DEVELOPMENT REVIEW APPLICATION

Minor Amendment to Site Plan

**RE: ALBUQUERQUE SCHOOL OF EXCELLENCE
13201 LOMAS BLVD, ALBUQUERQUE NM
MINOR AMENDMENT TO SITE PLAN
PLAT APPROVAL**

ENGINEER'S SEAL	ABQ SCHOOL OF EXCELLENCE	DRAWN BY pm
		DATE 7-2-2020
	ADMINISTRATIVE AMENDMENT TRAFFIC CIRCULATION LAYOUT	DRAWING 2019068-SP
		SHEET # SP-1
RONALD R. BOHANNAN P.E. #7868	TERRA WEST, LLC 5571 MIDWAY PARK PL NE ALBUQUERQUE, NEW MEXICO 87109 (505) 858-3100 www.tierrowestllc.com	JOB # 2019068

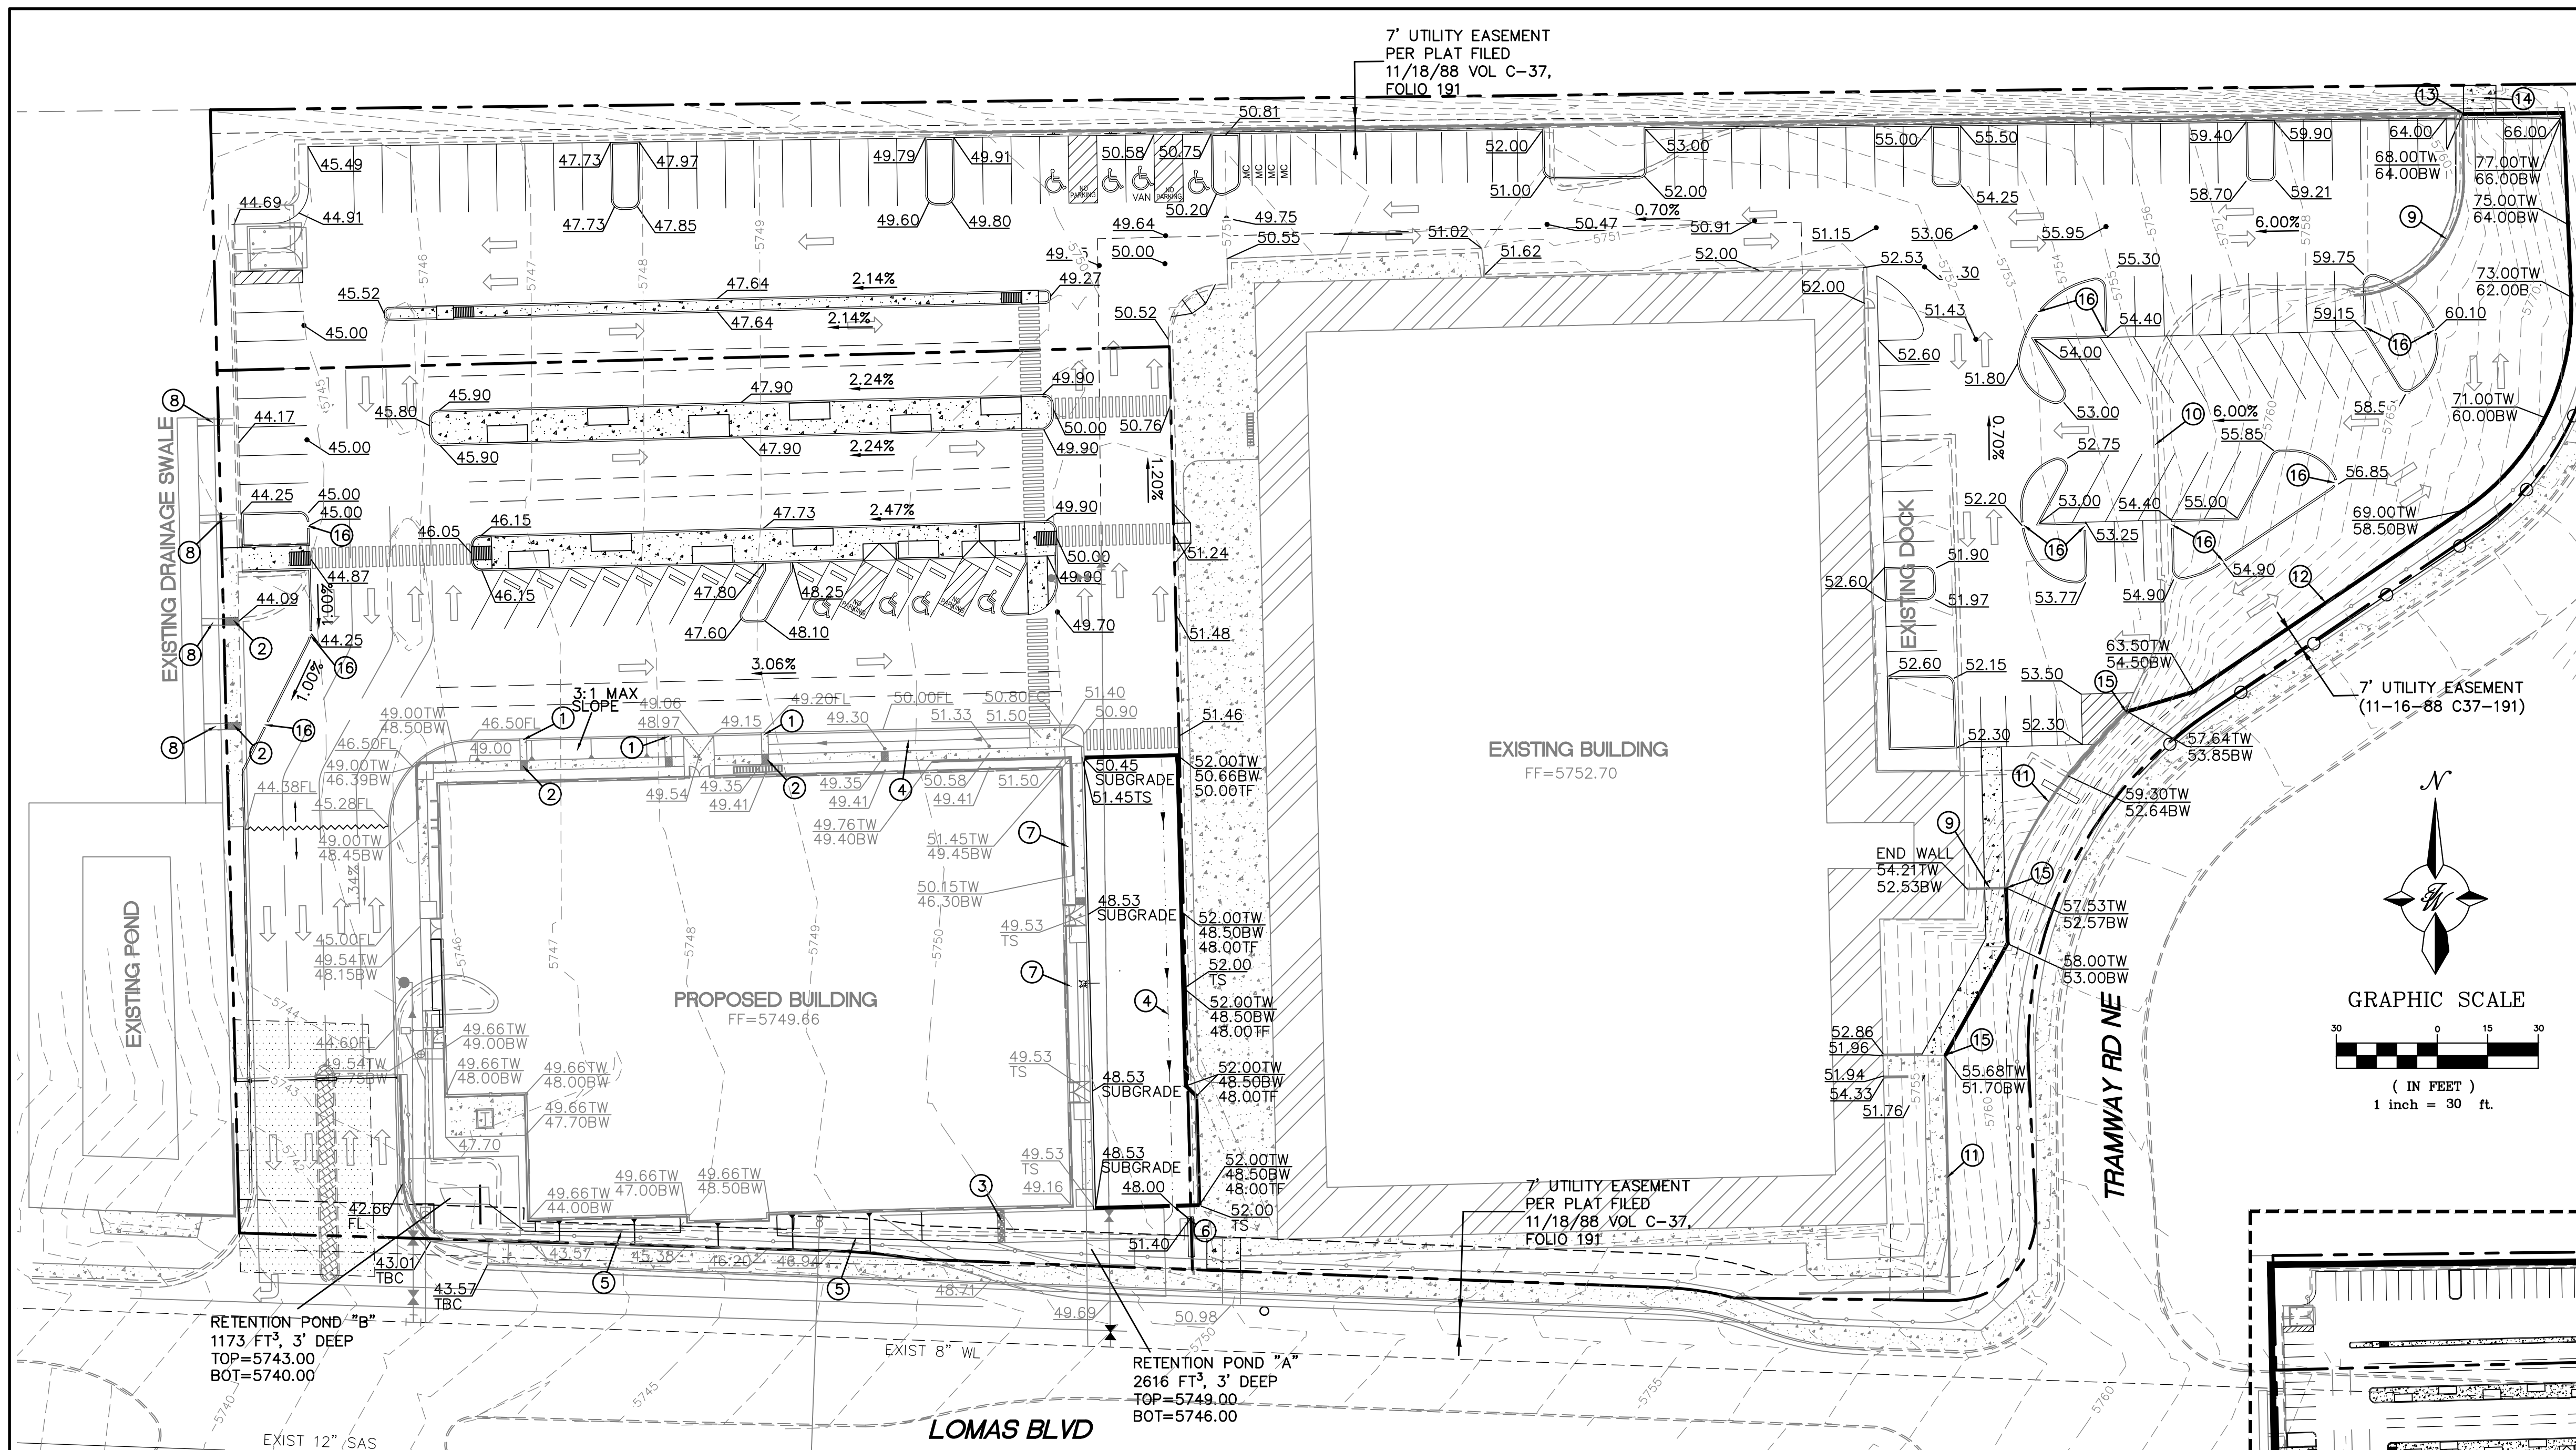
We request review and administrative approval of the attached Amended Site plan. The change to the Site Plan covers the parking lot. This new alignment was established to provide better traffic flow while dropping off students and picking them up. The revised layout also provides for a safer environment for the students during this activity. To compensate for the parking removed in the front parking field, new parking is located behind the building in an area previously used for truck unloading when the facility was a grocery store. If you have any questions, Please feel free to contact me.
